Access Compliance Report

Public Rights-of-Way

(Curb Ramps)

| Intersection ID: 48950 | Main Street: DAVID_JENNINGS_AV | Cross Street: BONROI_AV | Location: E |

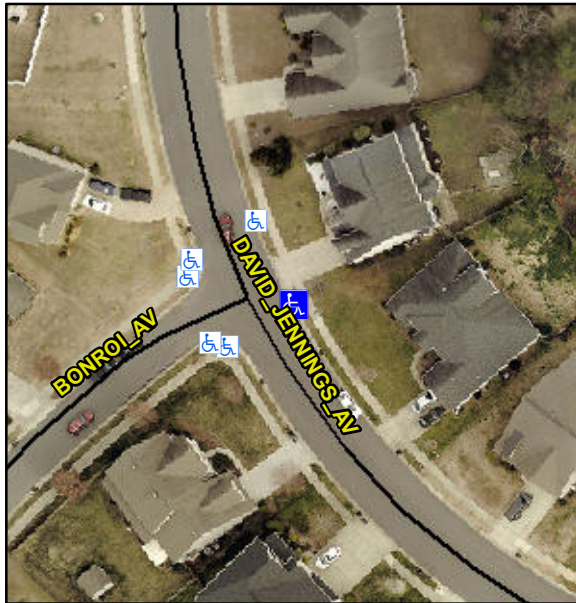
Not Found, R304.5.4

| Compliance | Description | Data | Compliance | Description | Data |
|------------|-----------------------|--------|------------|-----------------------------|------|
| Yes | Gutter Ponding? | No | No | Gutter Slope (%) | 9.8 |

**Remove & Replace Entire Ramp.
Remove & Replace Gutter.**
